**RE: Review of Form 28 Centralized E&P Waste Management Facility Permit  
Facility ID #441234, De Beque Water Station  
Black Hills Exploration and Production  
SESE Section 29, T8S, R97W, 6<sup>th</sup> PM, Mesa County, Colorado**

In response to your comment letter dated May 4, 2015, we have prepared additional information for the above-referenced project to address COGCC's comments and concerns. All comments that had a COGCC Comment of "None" were not addressed in our responses. The following information reiterates your comments and our specific responses to each comment as follows:

**11 OF 29**

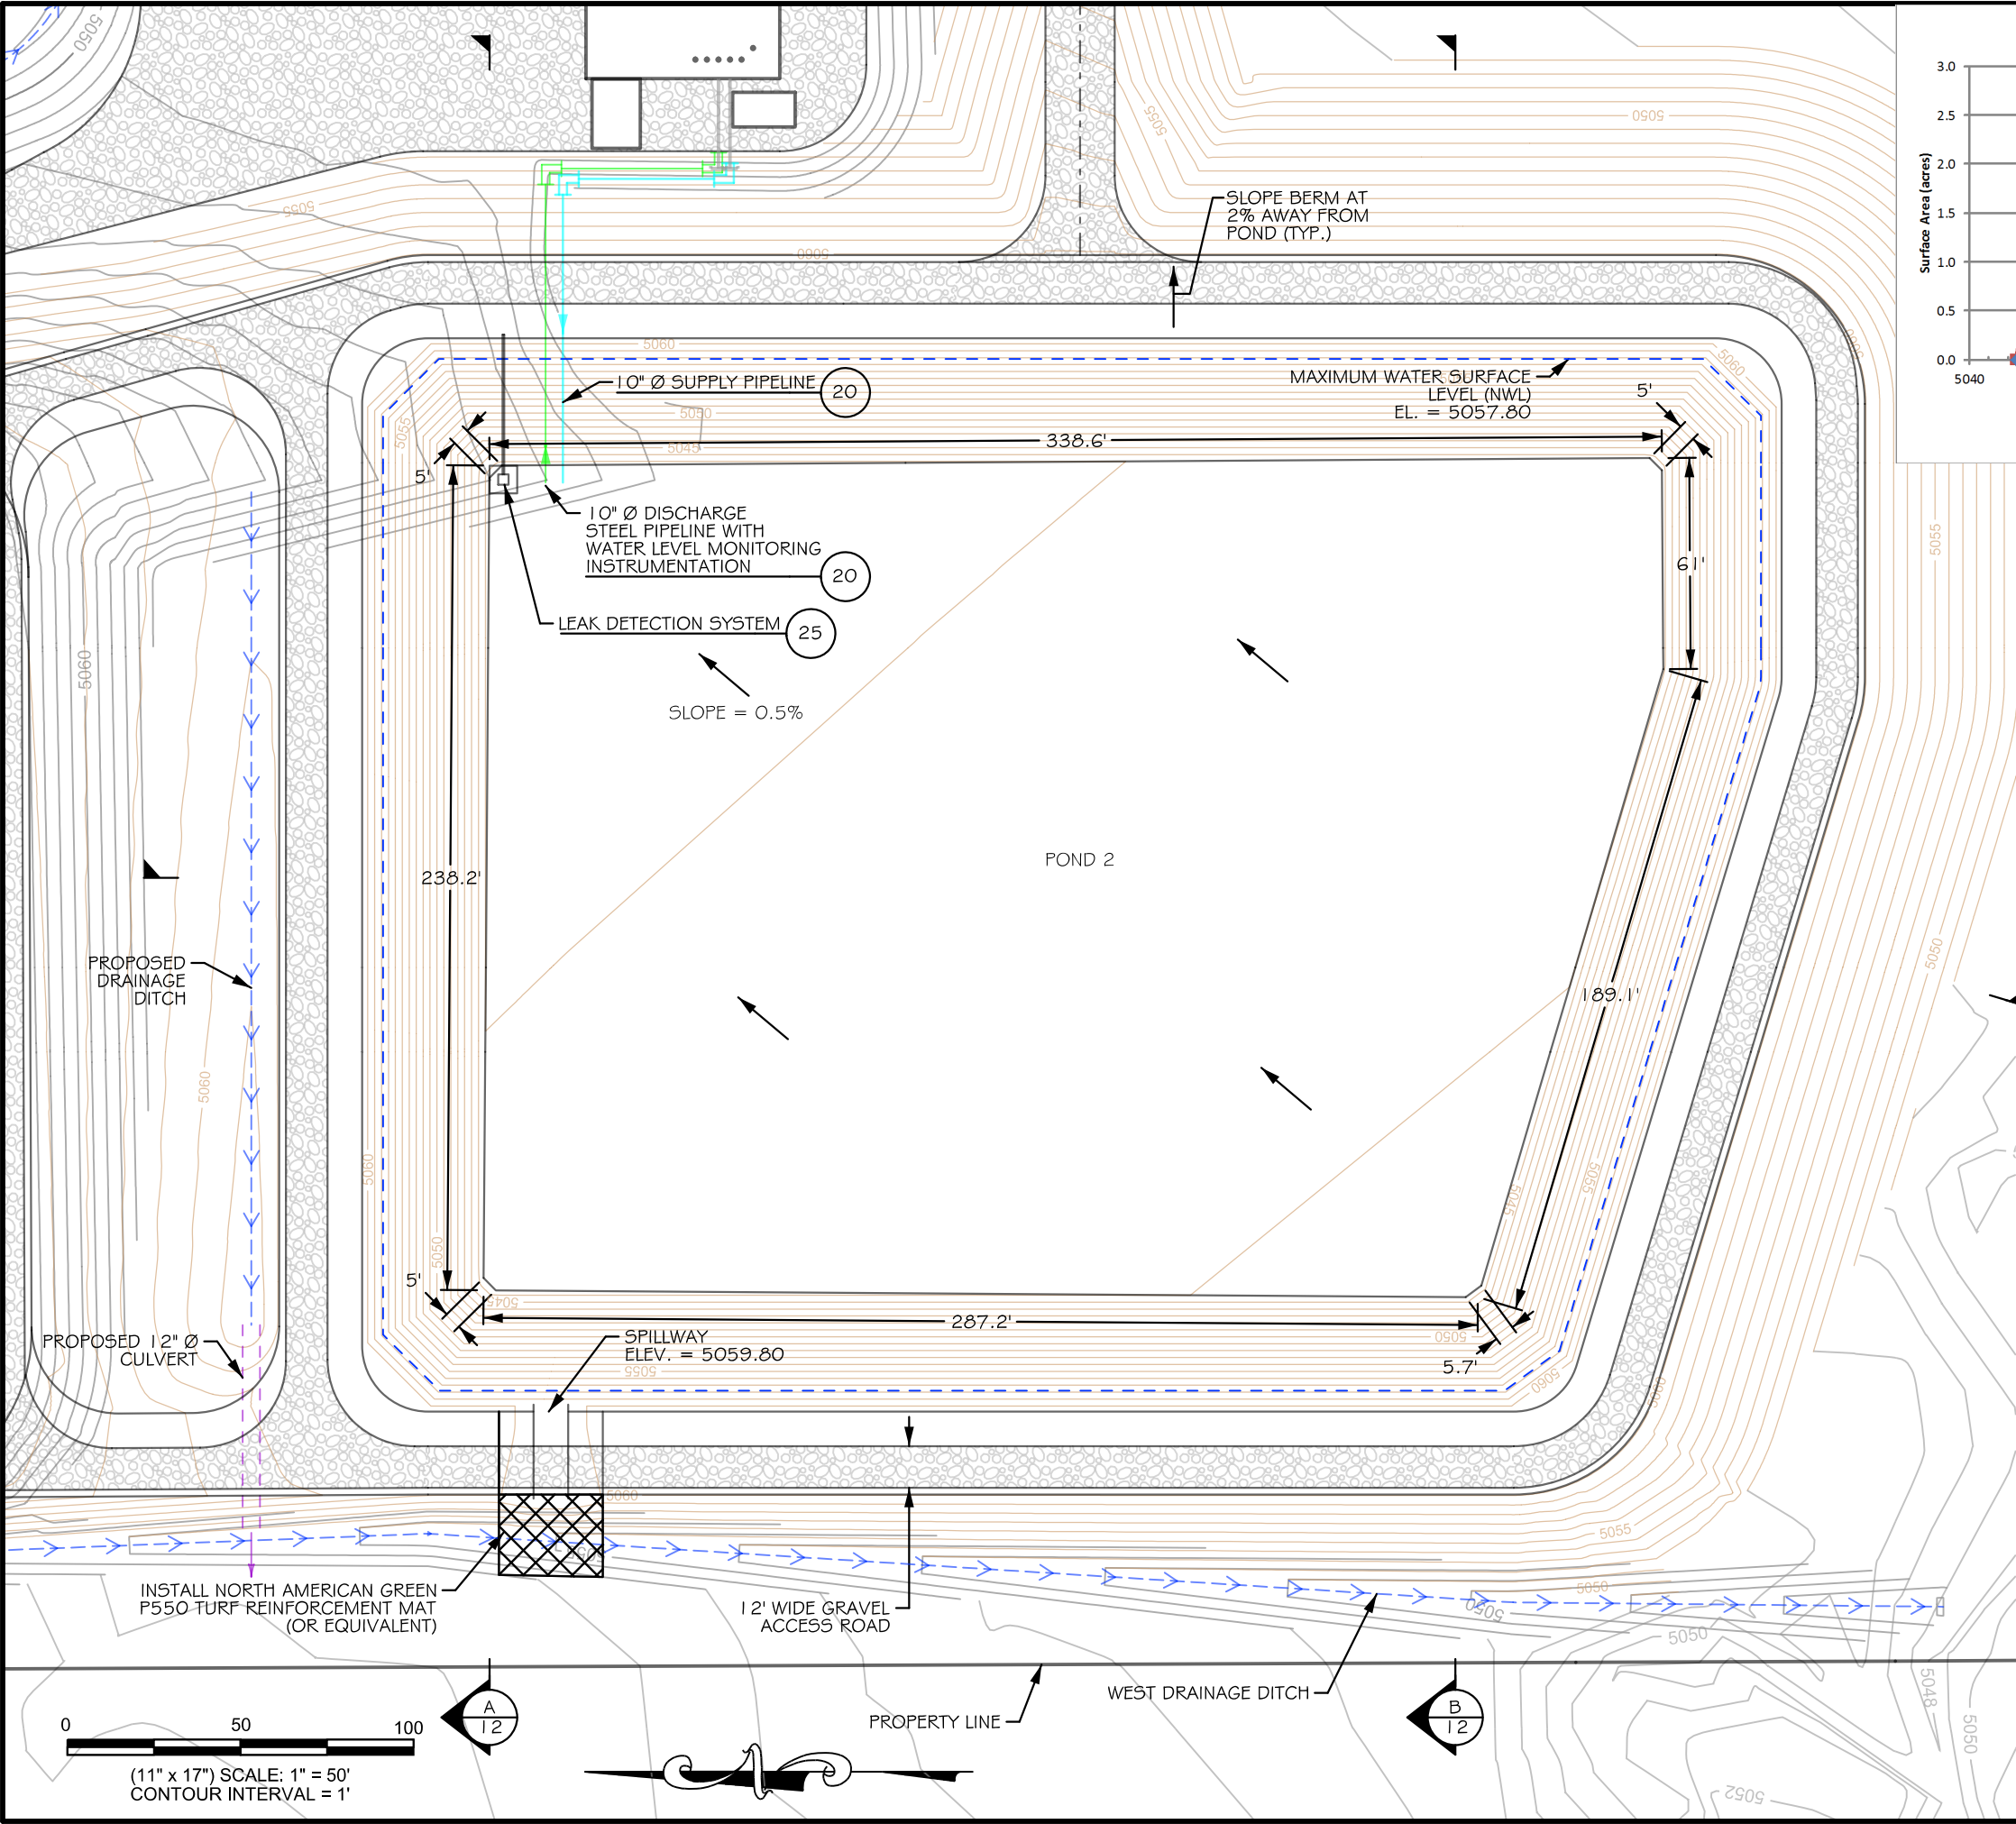
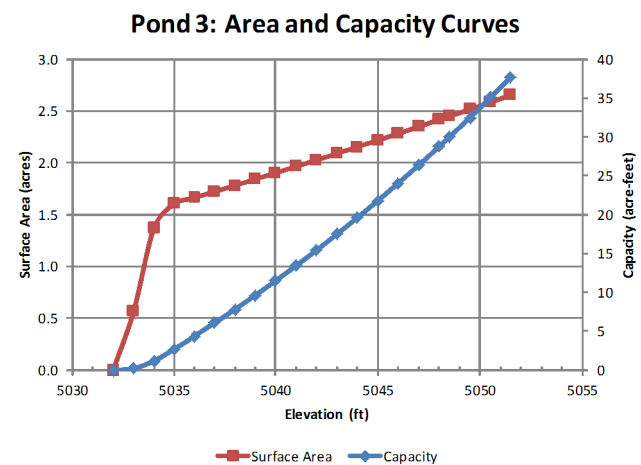
**COGCC Comment:** Sheet 11 of 29 shows the top of berm sloping away from the pits at 3%, the typical berm cross section on sheet 6 of 29 shows a 2% cross slope, please clarify.

**Response:** *The top of berm slope of 3% shown on Sheet 11 is an error and has been corrected to 2%. An updated Sheet 11 that shows the correct slope is located in Attachment G.*
